UNITED STATES PATENT AND TRADEMARK OFFICE

09/541,857

Office Action Summary	Application No. 09/541,857	Applicant(s) COLLIER ET AL. 	
	Examiner Tuan T. Lam	Art Unit 2816

DETAILED ACTION

FIG. 1A

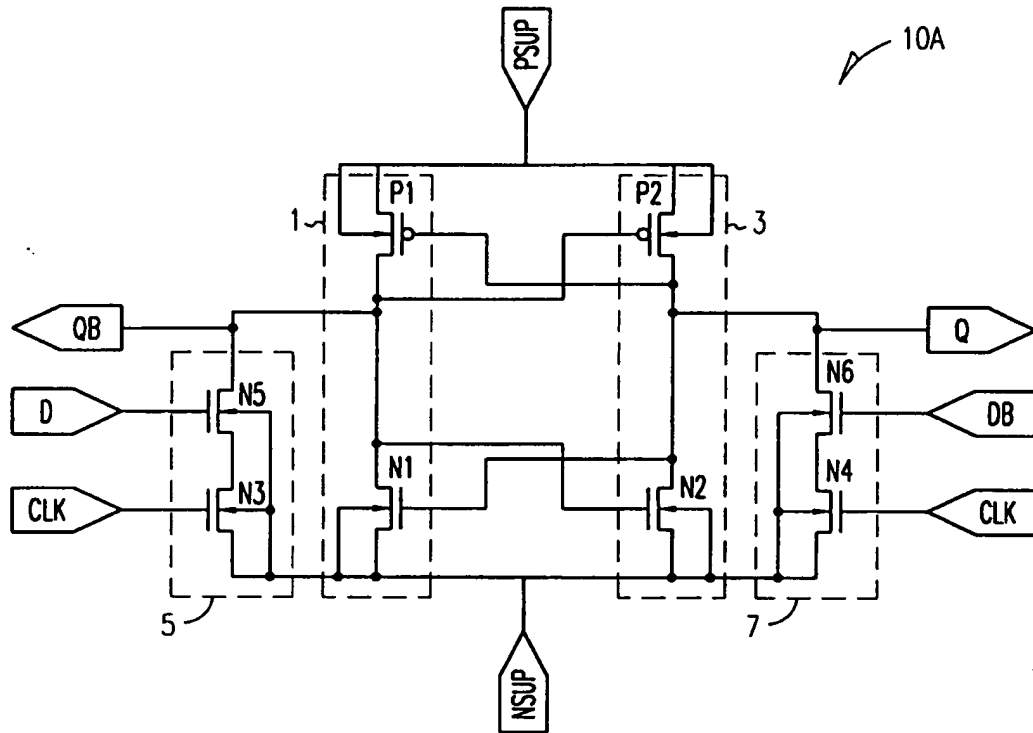
In FIG. 1A, reference number "10" is amended to "10a."

Approved
C. Lam

FIG. 1C

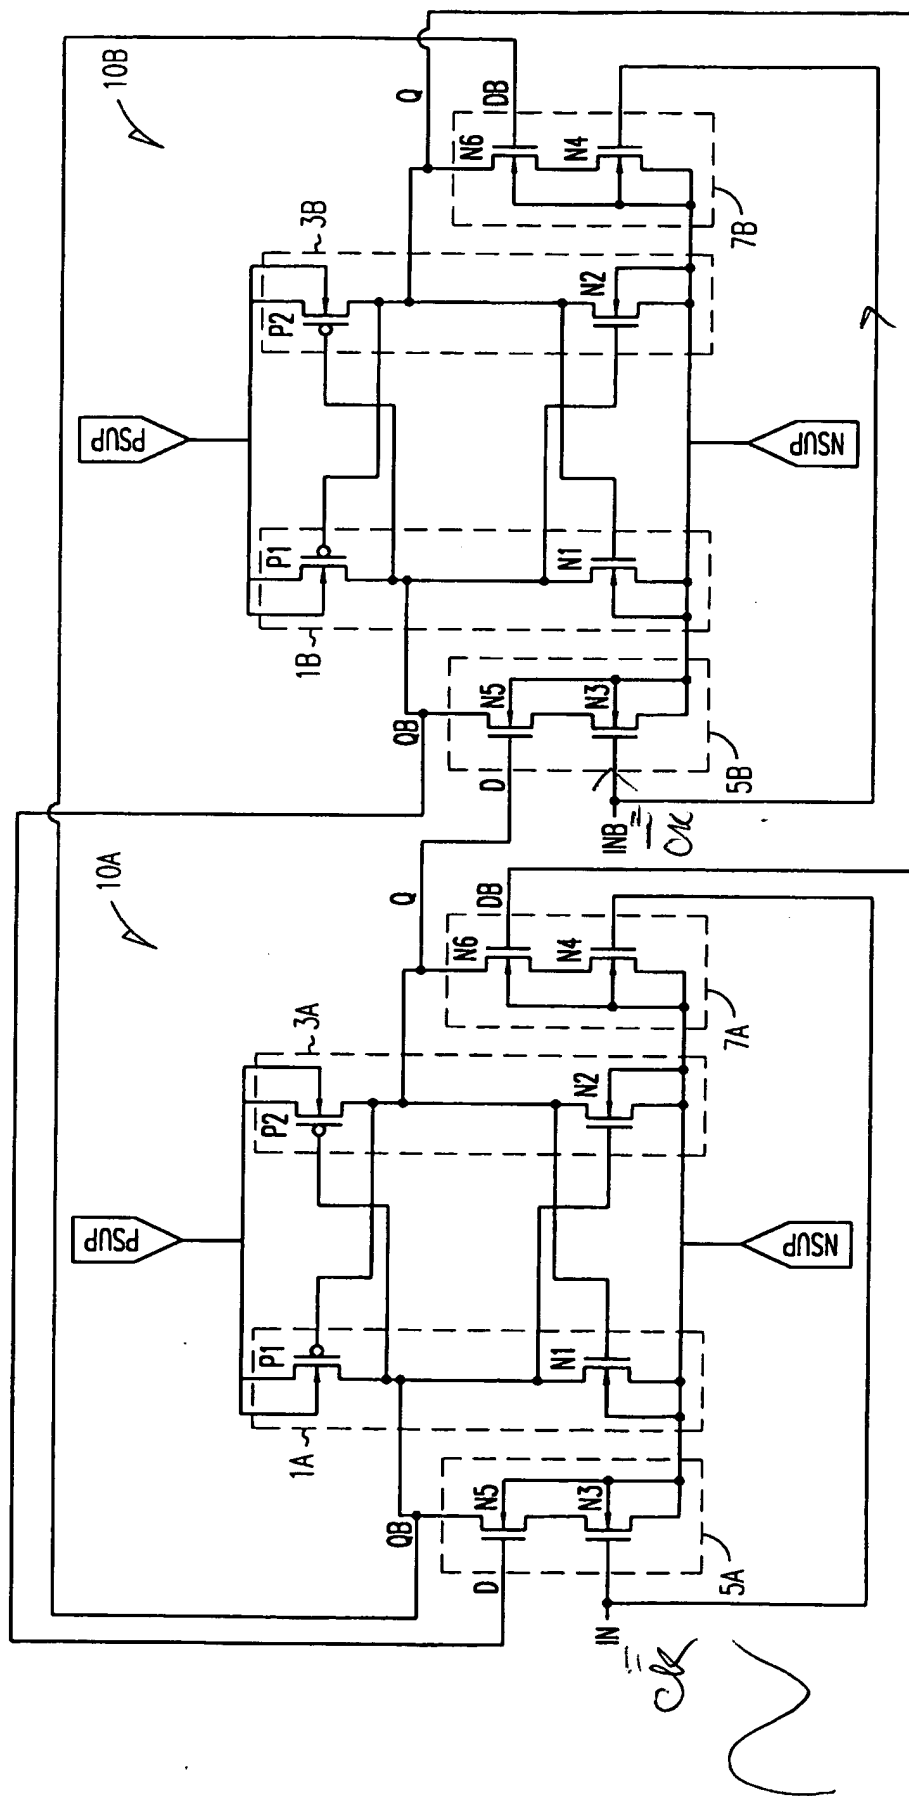
1. The disclosure is objected to because of the following informalities: the brief description of the drawings in pages 3 and 4 of the specification fails to include a brief description of figure 1c filed on 9/6/2005.

Regarding the rejection of claims 59-70, 72-73, 75-82 and 84-85 under 35USC 102(b) as being anticipated by Kouno (JP 60-224319), applicant argues that Kouno reference fails to show “wherein said first and second generating means arranged to generate the respective first and second periodic signals as analogue periodic signals having an amplitude which causes said transistors to be not fully open or fully closed but to act as variable resistance” as called for in claims 59, 75, 84 and 85. The Examiner respectfully disagrees. As stated in the rejection, the Examiner’s position is that since Kouno’s frequency divider has essentially the same structure as shown in applicant’s figure 1c (and all of the claimed structure and function set forth in the

Appropriate correction is required.
